TRACKSTER

SERVICE BULLETIN

STARTER ACCESS BOOT

FIGURE 1

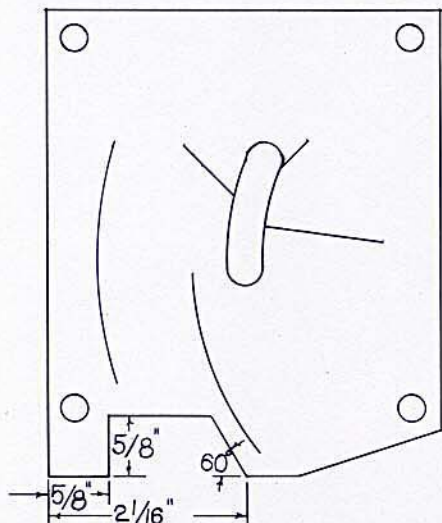
It has been brought to our attention that in some cases there is insufficient clearance between the starter access boot and the stationary pulley on the starter.

If this is encountered, it is recommended that the boot be removed and re-installed on the engine side of the fire wall. It will be necessary to cut out a small portion of the boot to make clearance for the adjusting bracket. See Figures 1 and 2.
